BUILDING COMPLETION REPORT

With reference to your letter no B.S.C 306/41
date 21-1-42, I have to return the plans after
complying with your requirements as under:-

With reference to your application dated **20th December 1941** with a plan for the proposed buildings/additions and alterations on plot No. **33** Survey Sheet No. **B.R.5, Bunder** Quarter I have to request you to comply with the following requirements:—

PLAN SHOWING THE PROPOSED BUILDING ON PLOT No 33. B.R.5.

PLAN SHOWING THE PROPOSED BUILDING ON PLOT No 33 & 34 B.R.5.

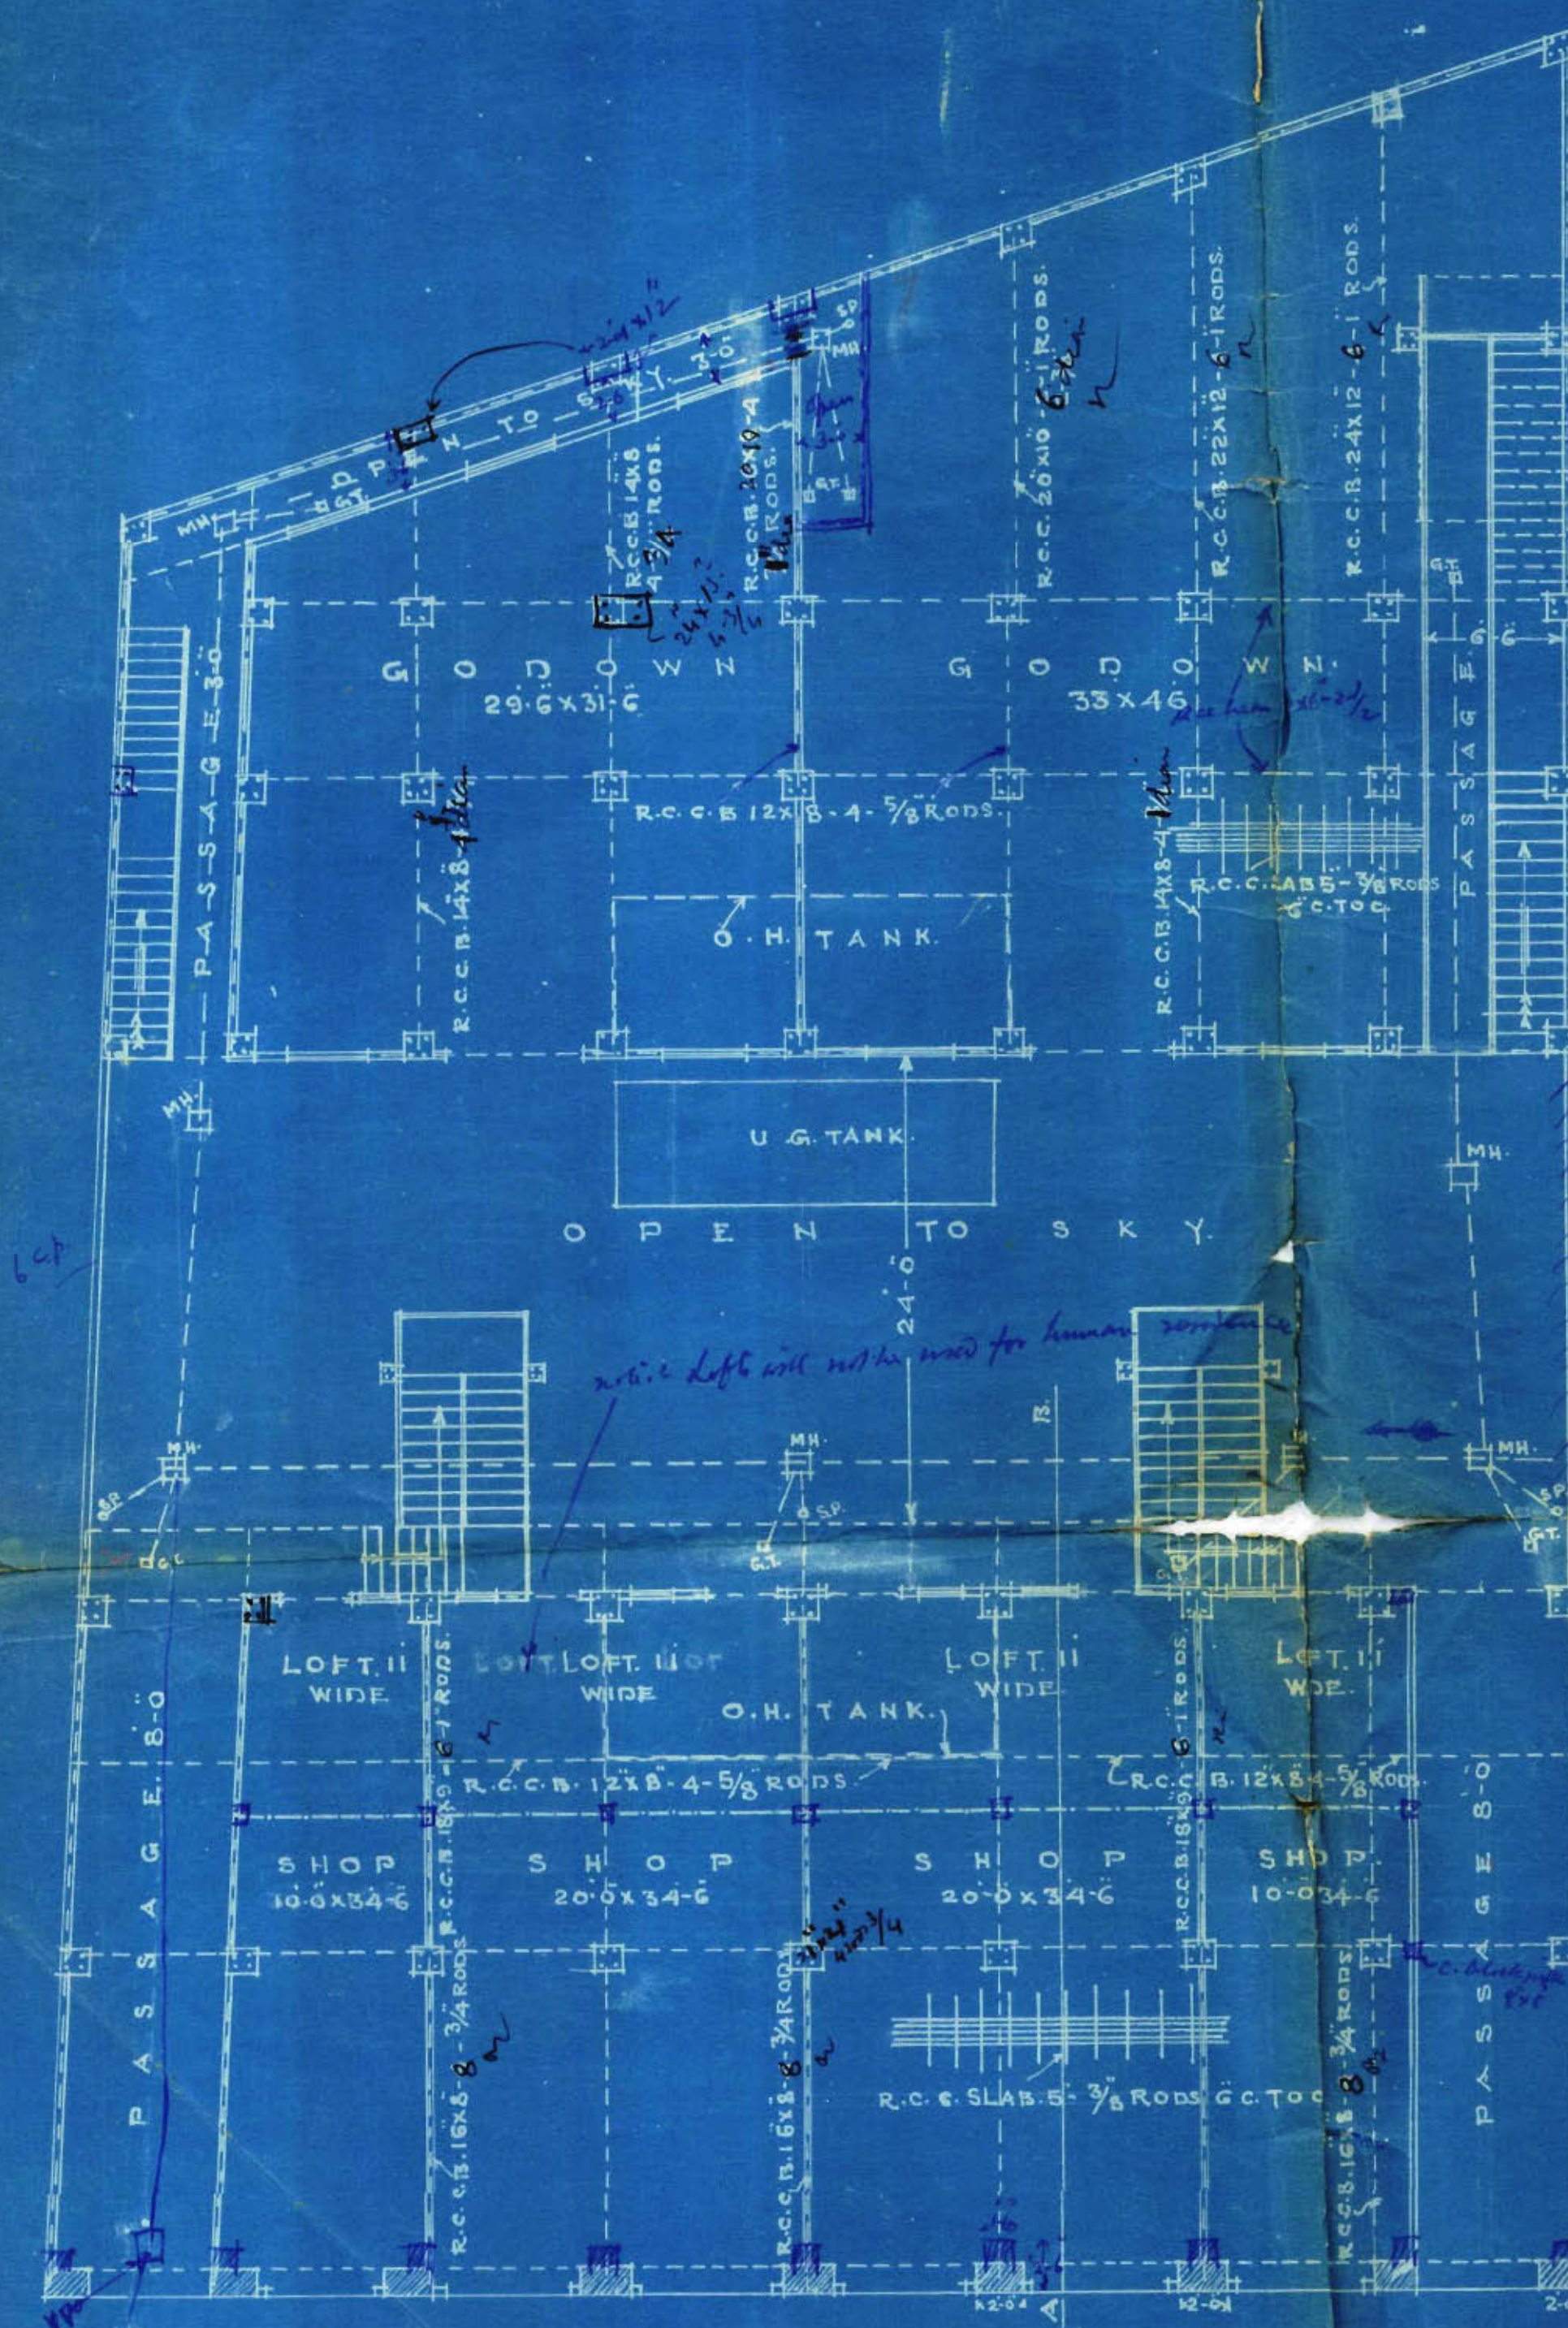
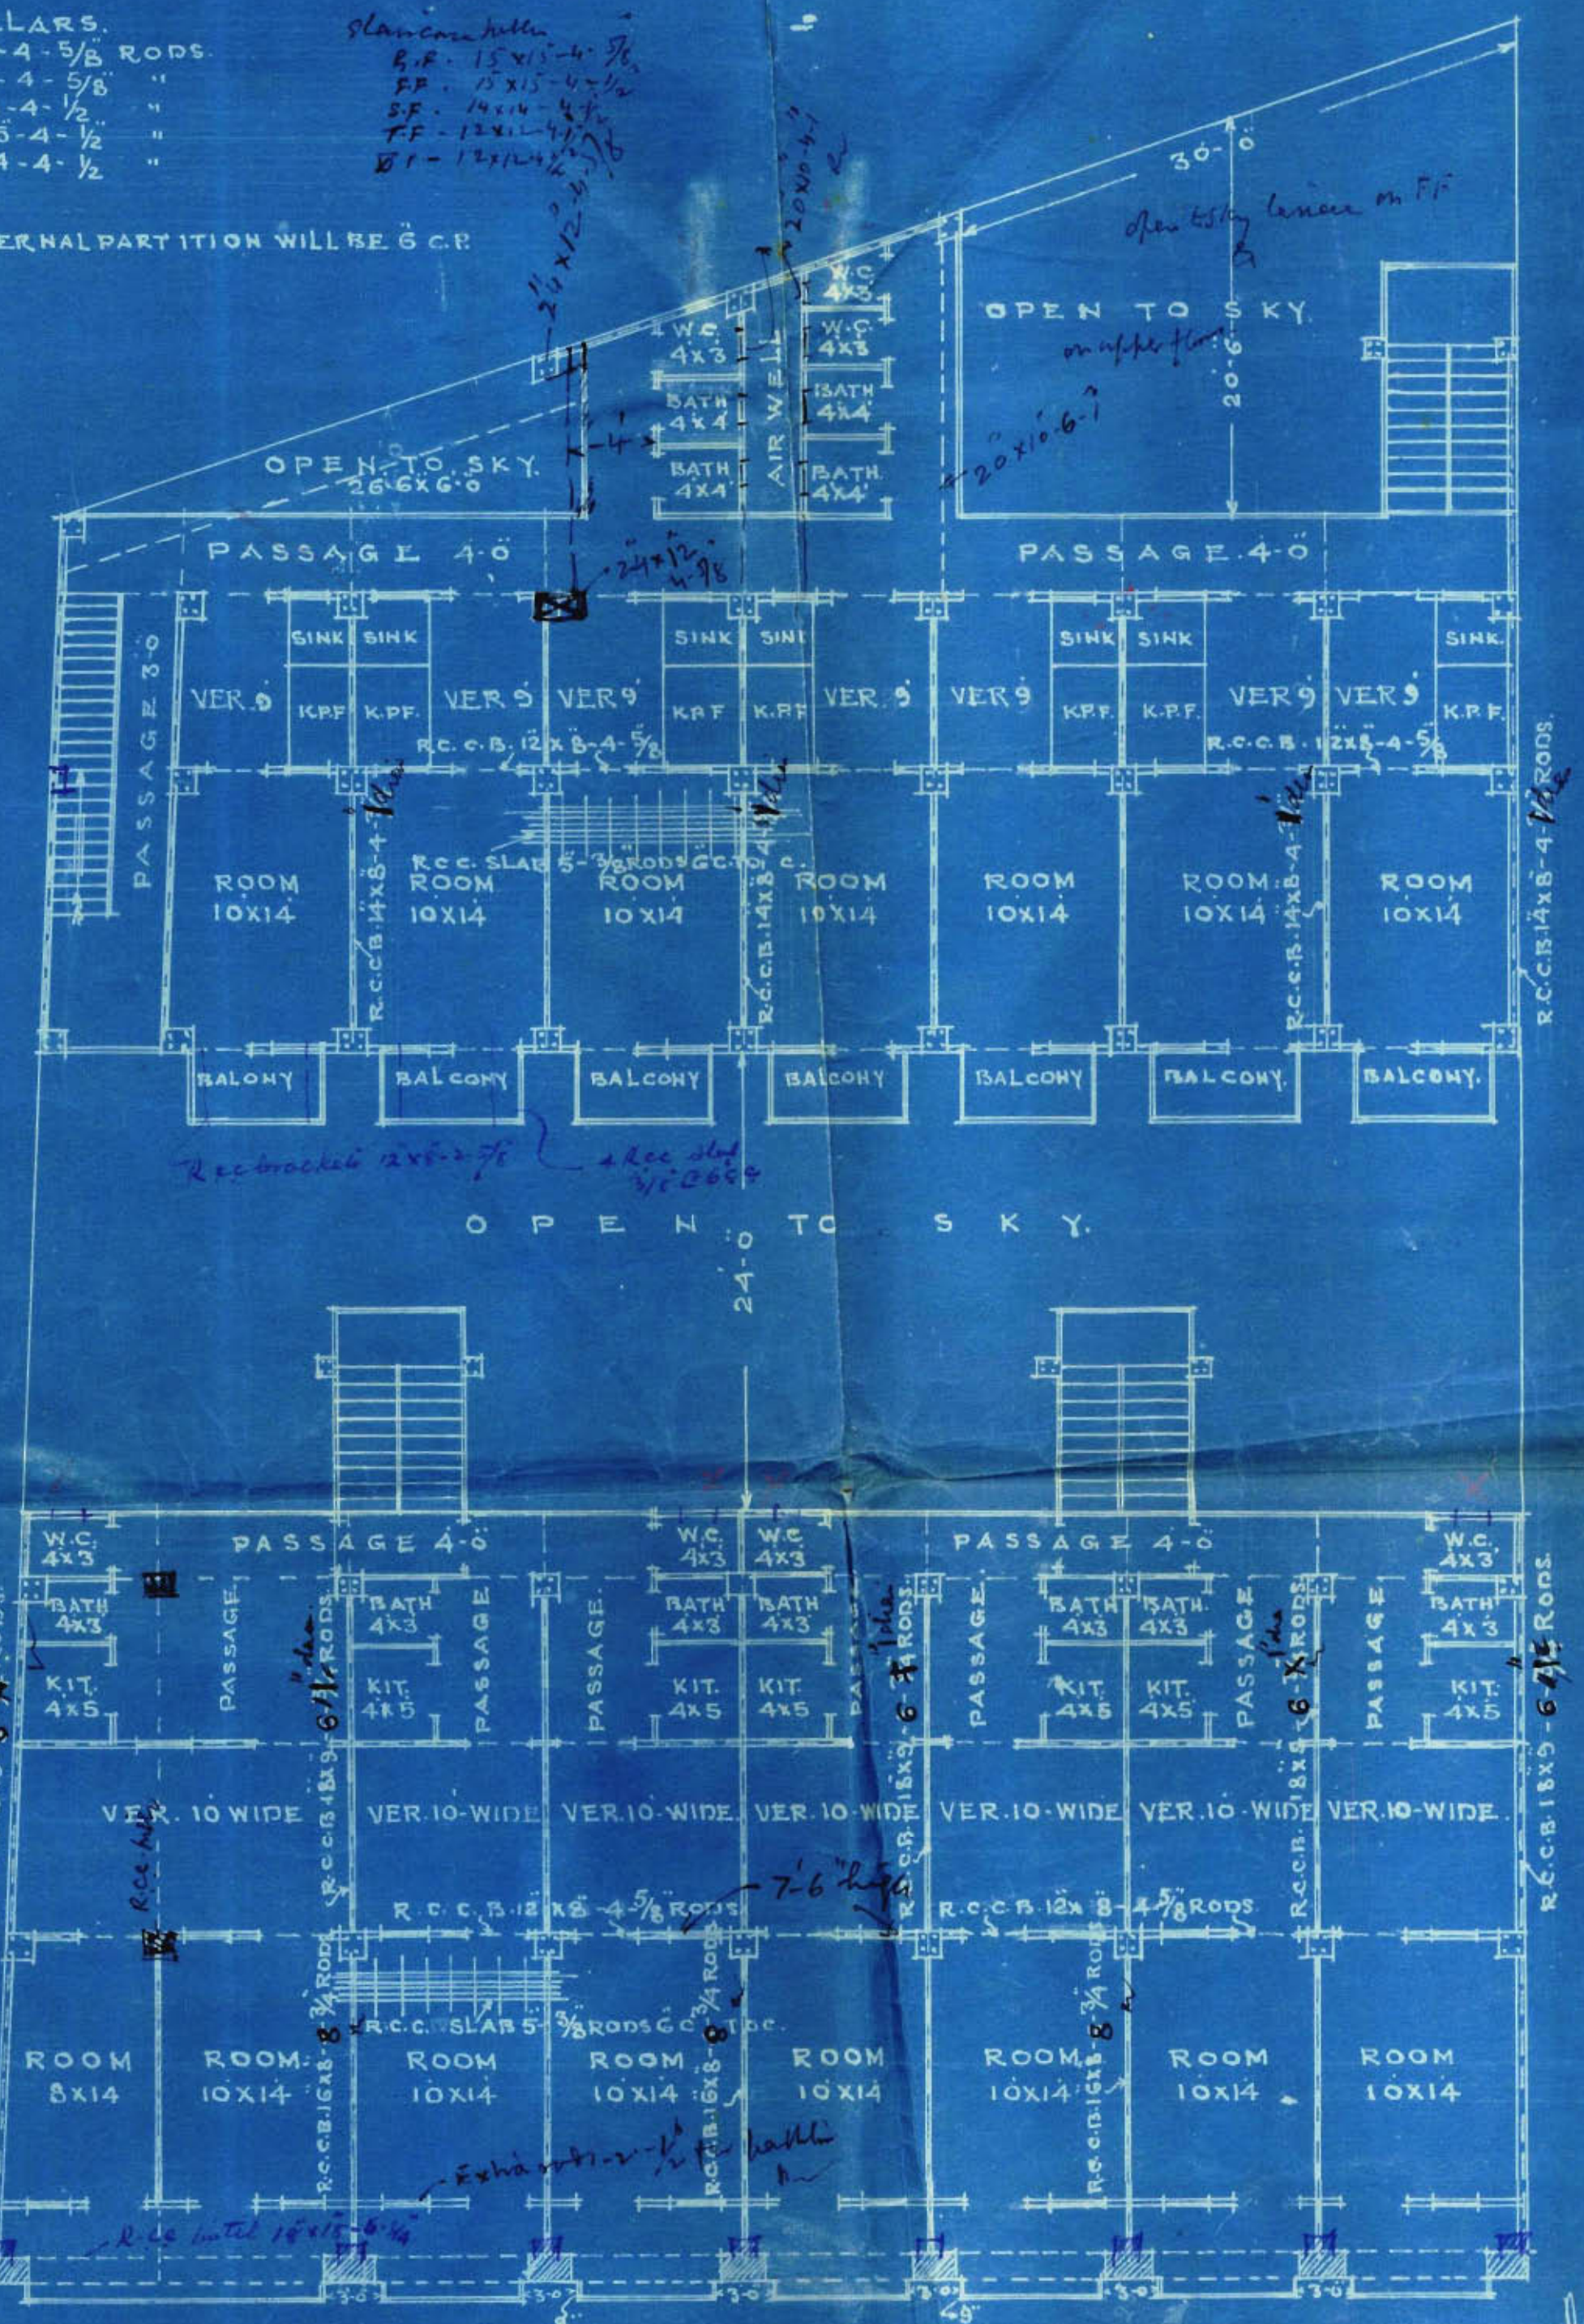
1. Staircase pillars are constructed as per sanctioned plan.
 2. External partition is kept 6".
 3. Passage on 1st floor converts into a shop.
 4. The Shop on 2nd floor retained on north.
 5. Lifts are constructed for which amended plans will be necessary.
- Other minor deviations

1. Two shops convert into one.
2. Long shop.
3. Part to be in shop.
4. Open space at the back of Godown.
5. Area of rooms.
6. R.C.C. Pillars between the front two rooms.
7. Size of pillars. including the stairs.
8a. Part in $3\frac{1}{2}$ " w. 10 ft. high.
- 19
